# Staff Report

## Tentative Partition Plat and Site Plan Review for Tree Felling

PA-03-24/ SP-06-24

May 6, 2024

EXISTING CONDITIONS/DEMO PLAN  
MORENO JACKSON ST PARTITION  
2336 JACKSON ST.  
ALBANY, OREGON

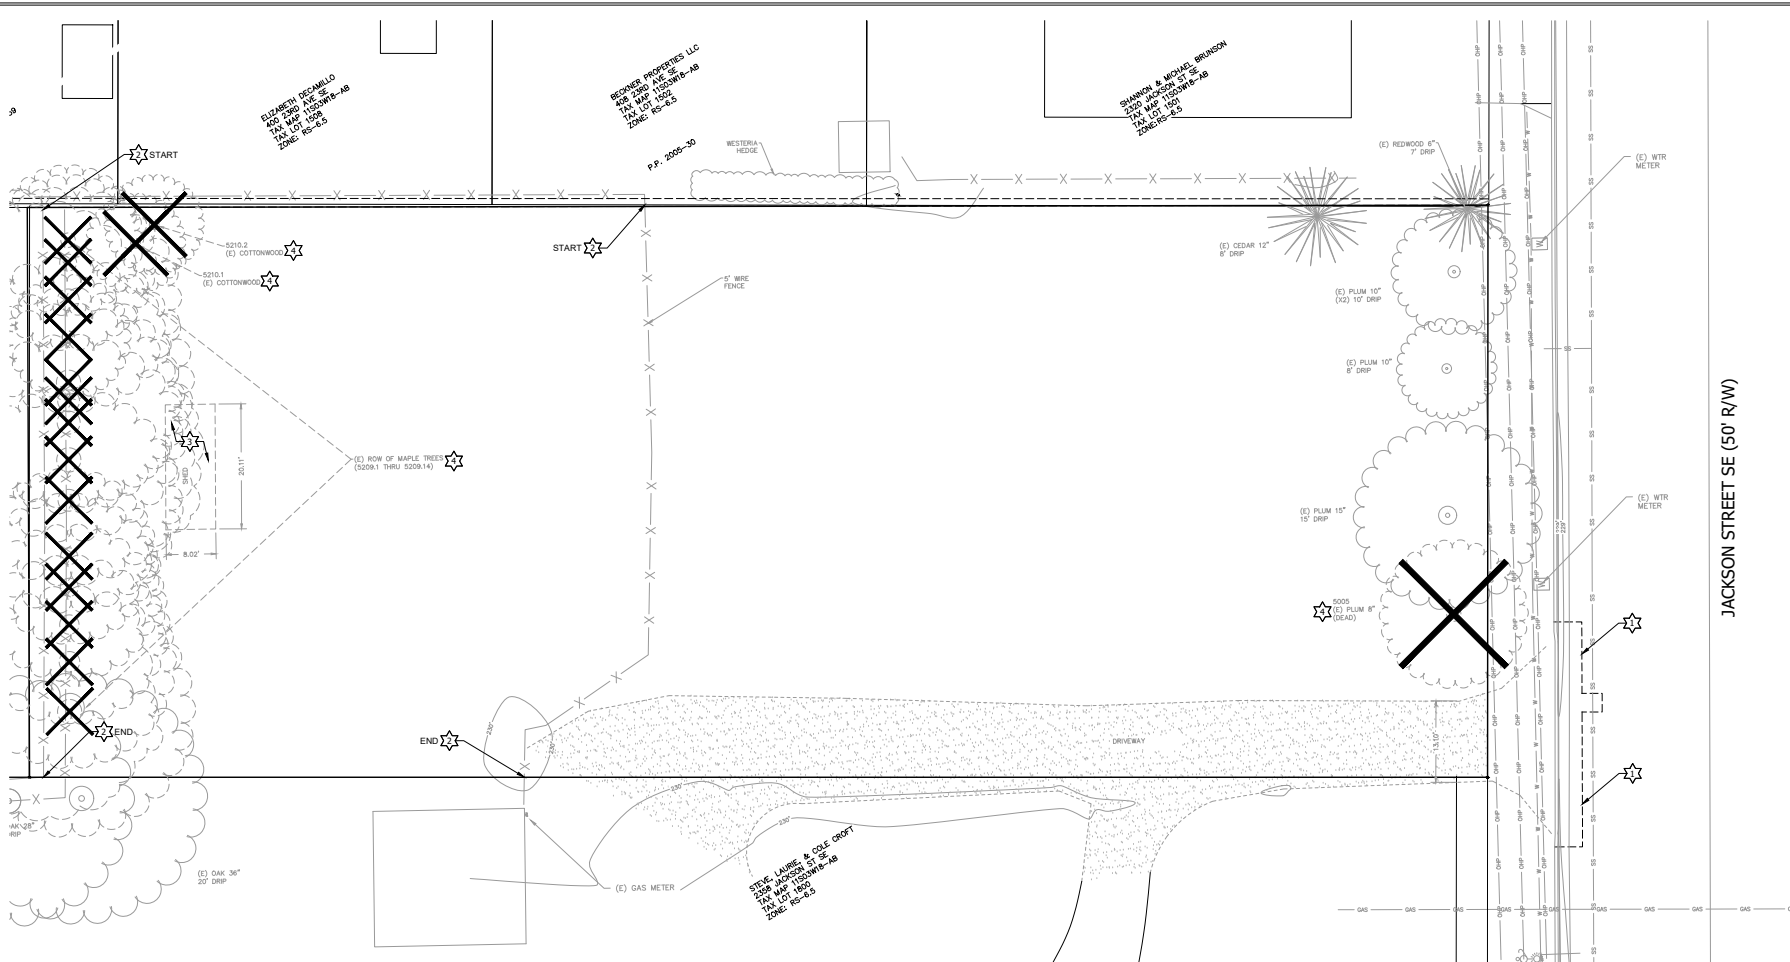
- Condition 6 In the event the proposed development does not take place, the identified for removal on the Existing Conditions Plan (Attachment B.1) shall not be removed without separate approval for tree felling not associated with development, using criteria listed in ADC 9.205(3).

**PRELIMINARY SITE PLAN**  
 MORENO JACKSON ST PARTITION  
 2336 JACKSON ST.  
 ALBANY, OREGON

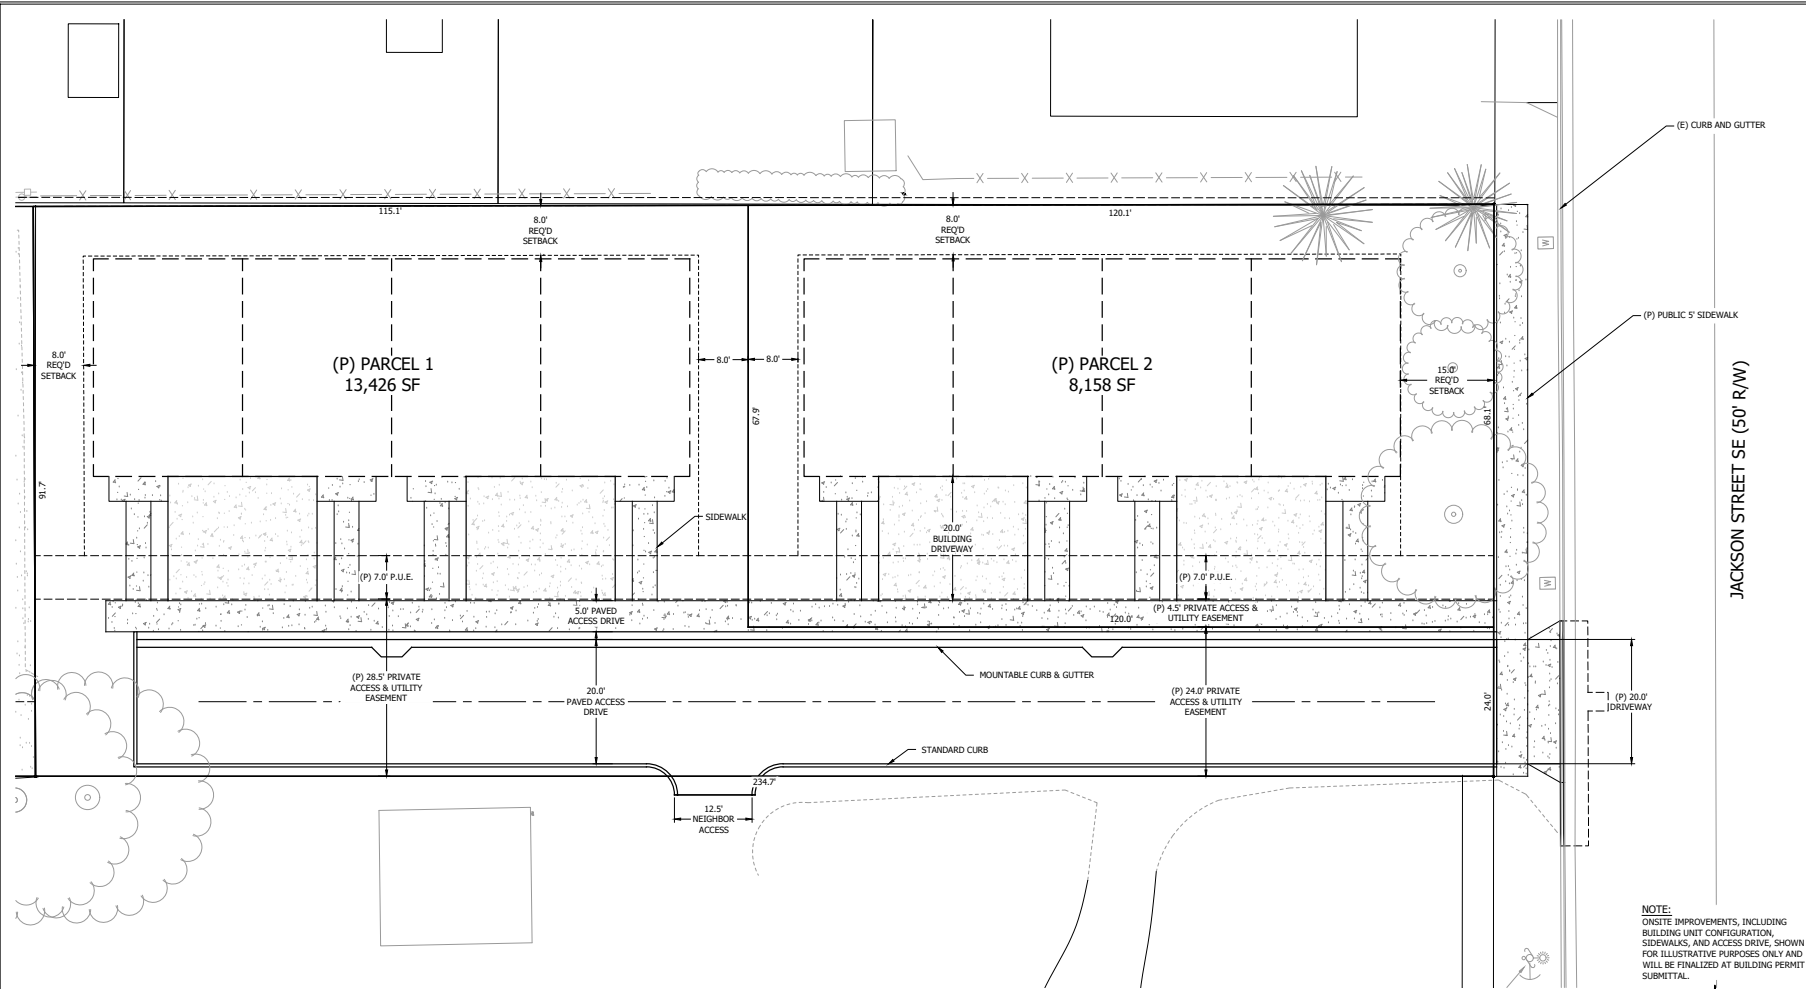
My property is the one that shares the ajoined driveway that runs between my house and up to the detached garage. When reviewing the information regarding the notice and the plans for construction, I noticed that the access to my property was restricted, blocking me from entering.

The plans show that the road being constructed for utility access, etc, only allows me to get to the detached garage but not the front access to the house. My property does have two access points from Jackson Street, one of them being smaller than the main proposed entrance for the road construction, but it's steep and narrow. This will be difficult for my elderly parents that reside at the property to come and go.

I've added red circles with numbers to explain how the tentative plans affect me and my elderly parents.

#1 is the small narrow access that we have from Jackson St which is rarely used. There are blind spots and its dangerous to pull out to the road. If the tentative plans went into effect, this would be the only way to get to the front part of the house. It would cost thousands of dollars to remedy.

#2 the plans show this access to the property is just road with a curb built in and no access to my home. This is the primary access point due to its width and ease of use. As mentioned, the plans, to my understanding, don't even include this.

#3 the plans show the is the only access to my property from the road construction. The proposed with is only 12 feet. This is an issue and inhibits future plans for property construction. and needs to be widened to accomodate equipment, etc.

**STAFF RESPONSE:** As there is not a recorded reciprocal access easement shared between your property and the subject property, your concern is a civil matter.
